# **SUBMISSIONS REPORT**

SSDA-10448 Mod 3 & SSD-46516461 WH9  
Aspect Industrial Estate

Prepared for  
**MIRVAC**

Figure 1 Refined Estate Masterplan

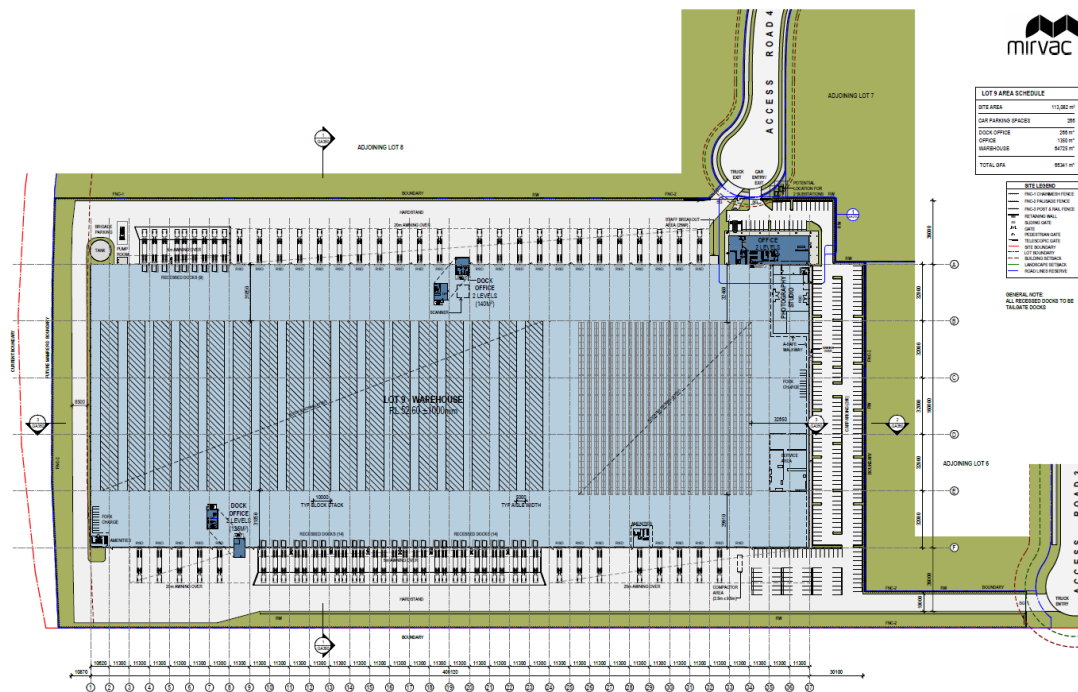
Location	Proposed Refinements
<b>SSD-10448 MOD 3</b>	
<b>Lot 1</b>	Updated layout of Lot 1 and alignment of vehicular access to Warehouse 1 from Access Road 1 to reflect the approved estate masterplan under SSD-10448 MOD 2.
<b>Lot 9 / Warehouse 9</b>	Updated warehouse and lot layout for Warehouse 9, consistent with the concurrent WH9 SSD. This includes updates to the hardstand parking provision, bicycle parking, tree plantings and pedestrian access. The refined Warehouse 9 layout is detailed below.
<b>Warehouse 9 (SSD-46516461) Refinements</b>	
<b>Warehouse 9 Carparking</b>	The hardstand carparking (located at the south hardstand area) will be refined to deliver a total 257 car parking space (reduction of 9 spaces from the hardstand area).
<b>Warehouse 9 Tree Plantings</b>	The provision of tree planter islands across the Warehouse 9 car parking areas has been refined to provide 28 tree planter islands (increase from 22 islands) to meet MRDCP requirements.

Refer to the revised Architectural Plans (**Appendix A & Appendix B**) for further details on the design refinements made since public exhibition.

Picture 1 Original Proposal

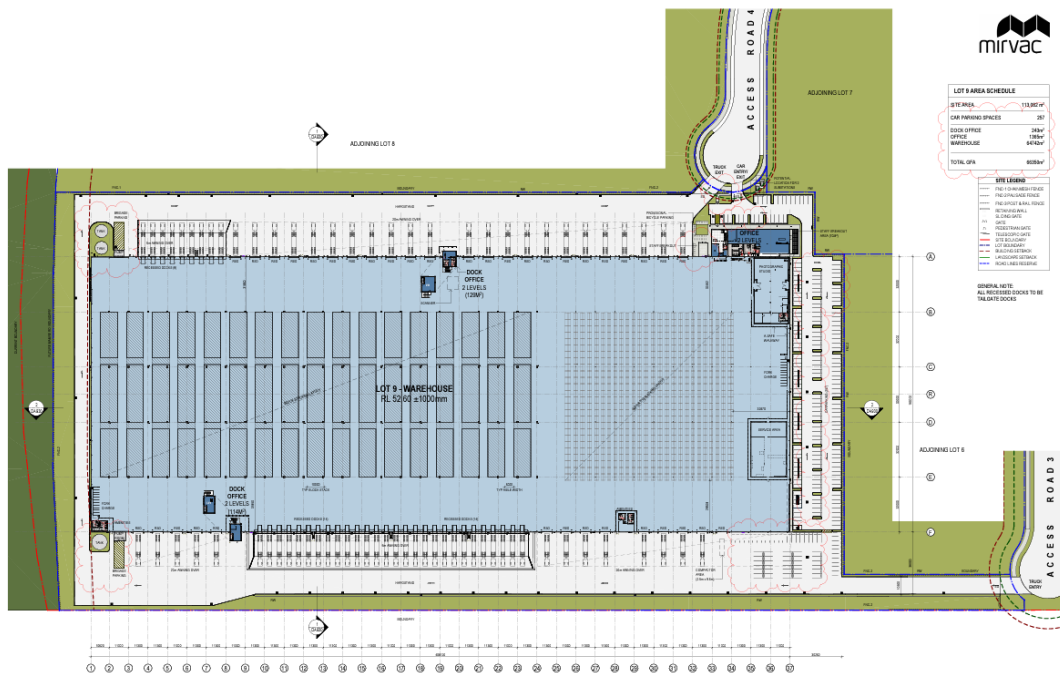
Location	Proposed Refinements
<b>Warehouse 9 Rooftop Plant</b>	The architectural drawings have been refined to demonstrate the location of the rooftop smoke exhaust fans.
<b>Warehouse 9 Pedestrian Access</b>	Adjusted pedestrian access to improve safety.
<b>Signage on Western Elevation</b>	It is noted that there is a minor non-compliance with the Mamre Road DCP, in terms of the extent of the business identification signage on the Mame Road frontage of the proposed warehouse building. Although it is considered that the extent of this façade could accommodate two signs, it is now proposed to remove one of the proposed signs at this location. The future operator of the warehouse is currently considering which of the two proposed signs they would wish to remove, so at this stage the Warehouse 9 Architectural Plans have not been updated to reflect this. However, it is intended that this will be completed prior to determination.
